**Display**Date: **March 16, 1992**Subject: **HORIZONTAL PICTURE NOISE**Model: **BVM-1912**Serial No: **1,000,001–2,000,152****DESCRIPTION**

**Figure 1**

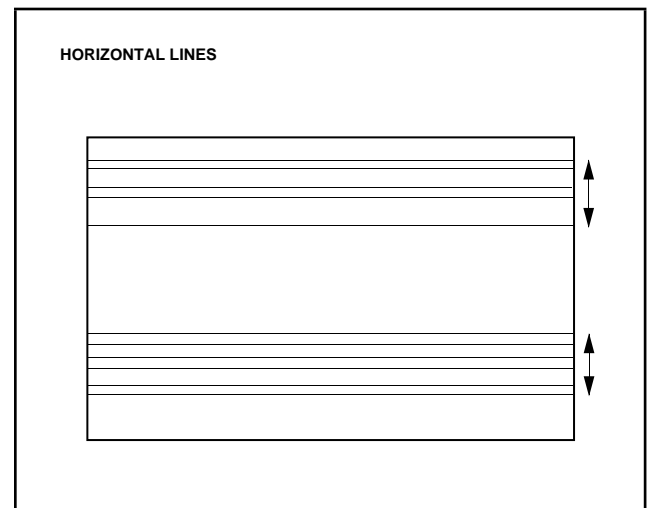
Depending on the position in which RV1 on the DD board (pulse width adjustment) is set, occasional crosstalk in the AFC pulse (IC15-1 CK) may occur, and horizontal lines caused by internal oscillation may appear on the screen, moving up and down at random as shown in Figure 1.

Figure 2

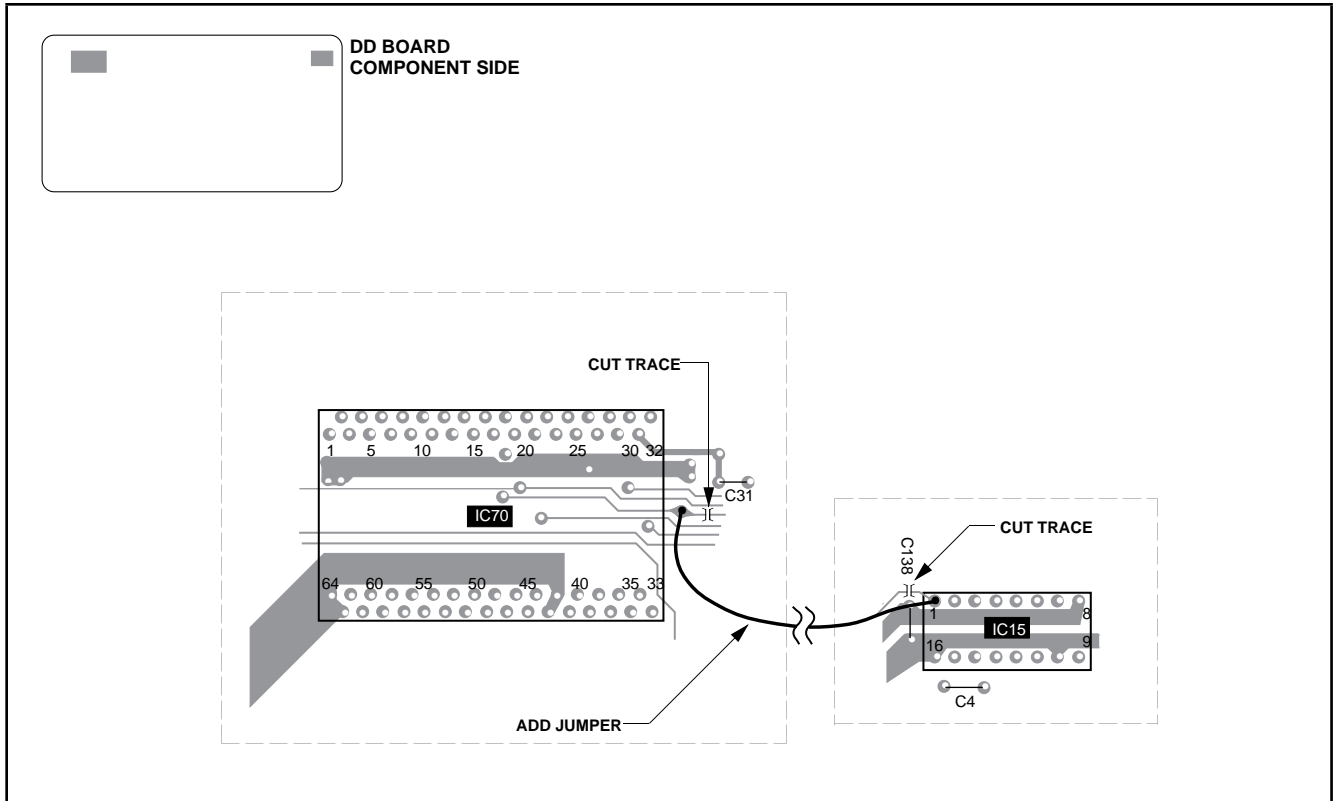
**MODIFICATION PROCEDURE****DD Board****Solder Side****(See Figure 2.)****NOTE:** IC15 (74HC123AP) is most affected.

1. Cut two traces as shown.
2. Solder 160mm jumper between thru-hole (connecting to IC78-14) and IC15-1.
